Subject: **Request for Modification for Section 404 Individual Permit and Section 401 Water Quality Certification** for the I-40/I-77 interchange improvements including I-40 from west of SR 2003 (Radio Road) to SR 2158 (Old Mocksville Road) and I-77 from south of SR 2321 (East Broad Street) to south SR 2171 (Jane Sowers Road) in Iredell County. Division 12, TIP I-3819B. Debit \$570.00 from WBS 34192.3.2

Revisions resulting in changes to permitted impacts are proposed at two impact sites (Sites 22 and 23). Two new impact sites (Sites 22A and 22B) have been added within the footprint of the previously permitted Site 22. The changes to these sites are described below.

PERMIT DRAWING
SHEET 1 OF 67
Rev. 11/29/2022

PROJECT REFERENCE NO. 1-38198 SHEET NO. 19

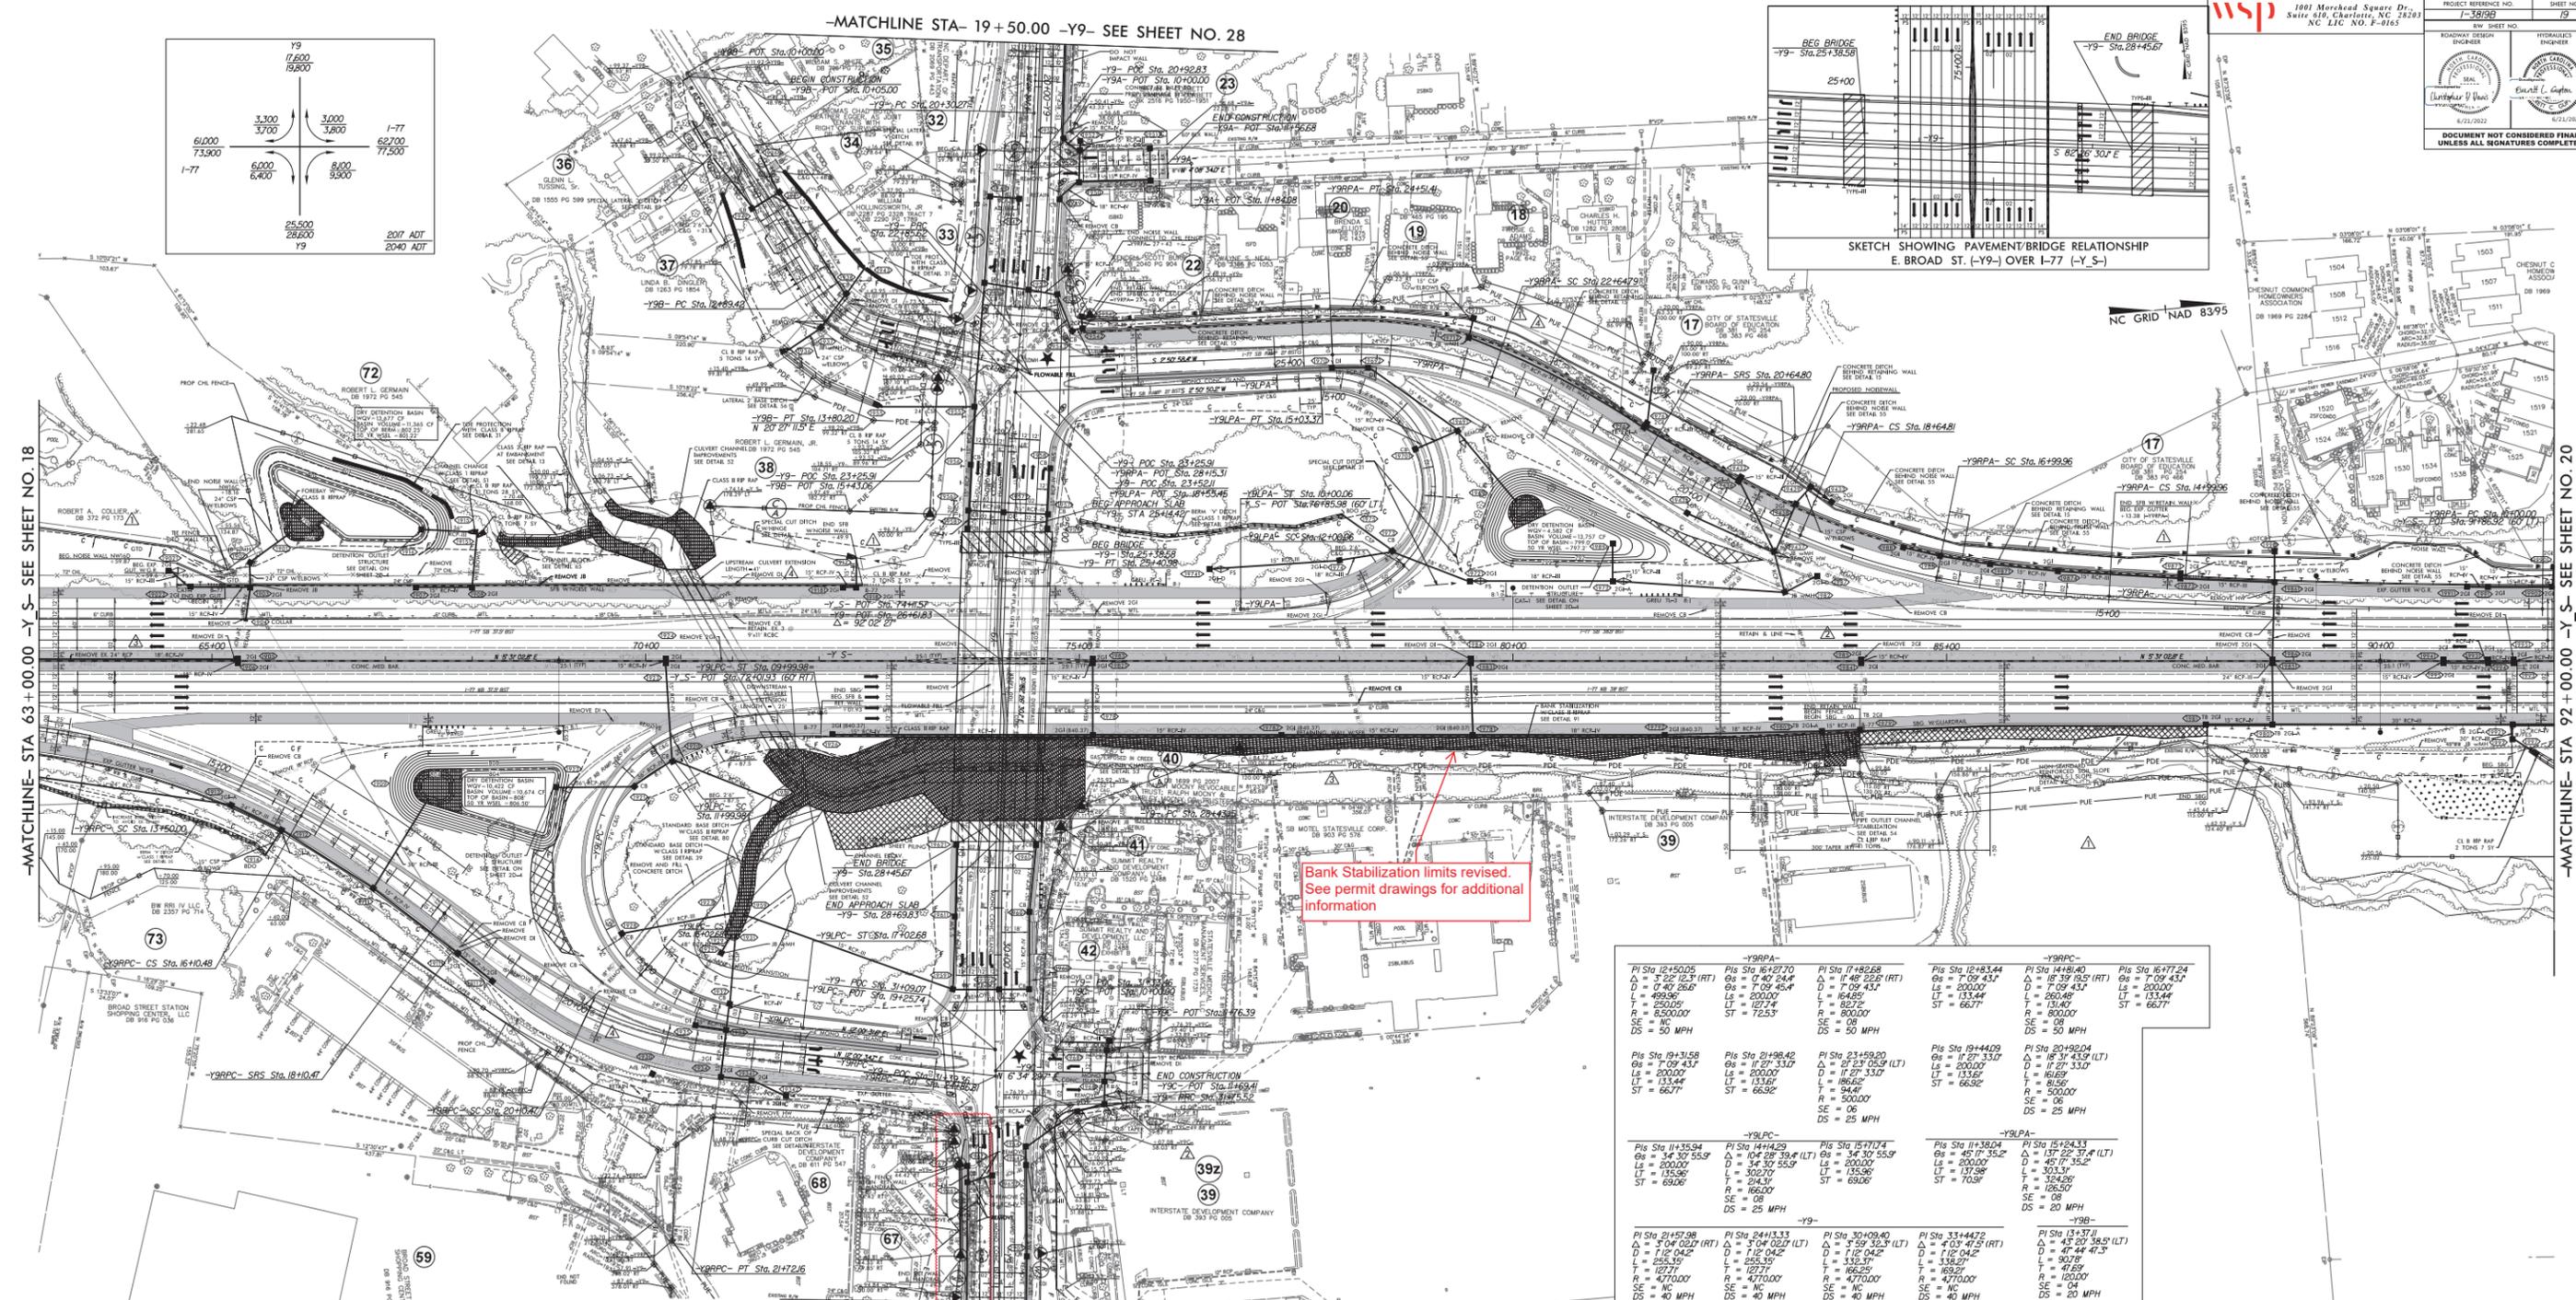
Bank Stabilization limits revised. See permit drawings for additional information
